**VAN HOOL SERVICE BULLETIN #1126 - OWNER'S NOTIFICATION LETTER UPDATE**  
**IMPORTANT MESSAGE PLEASE READ IMMEDIATELY**

Re.: NHTSA Safety Recall Program-Campaign number 04V - 422  
Van Hool Service Bulletin N°. 1126 "Main junction box – top cover", section Parts and products

**Figure 1:**  
VH 10906063 old  
and new – do not  
use the shorter  
version

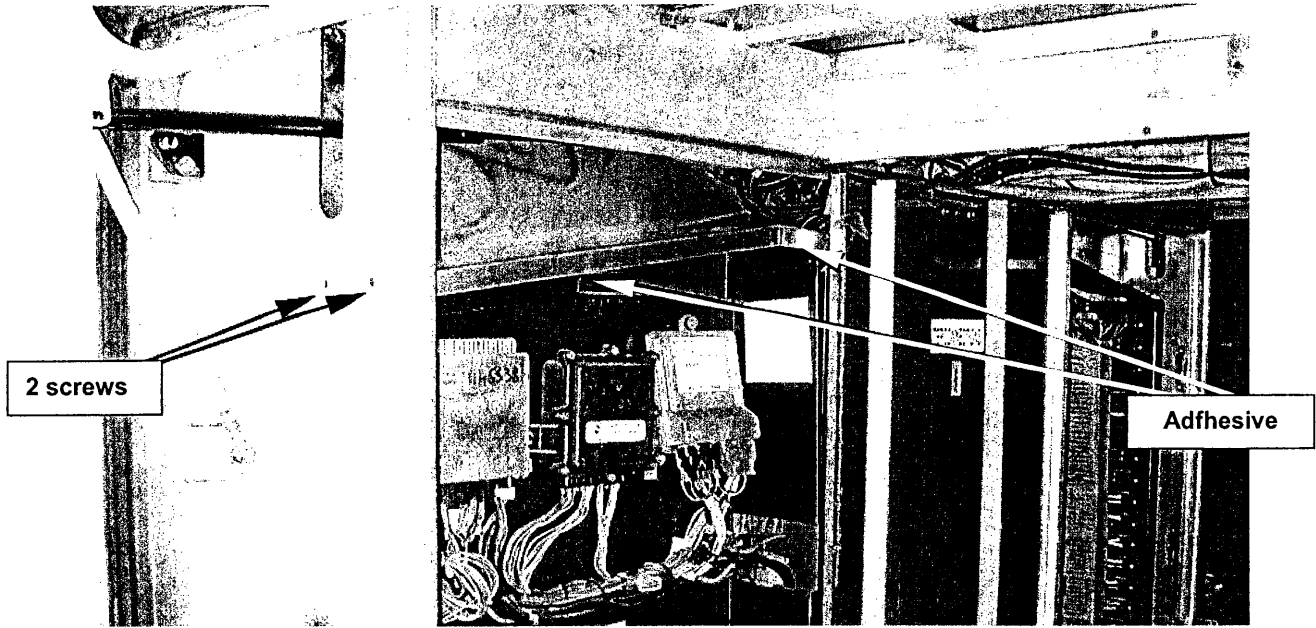
Left-hand junction box top cover N°. VH 10906063, which has been supplied to you as a repair part to use for the above-mentioned campaign has been determined unsuitable for this application.

Please find enclosed a replacement top cover, which has been tailored to your coach's junction box. The new part is 4 inches longer than the old part (see Figure 1) and can be attached to the junction box center section using adhesive, and to the junction box side wall with two sheet metal screws (see Figure 2).

**IMPORTANT:** Please do not use the shorter version of Van Hool cover VH 10906063. Scrap it instead.
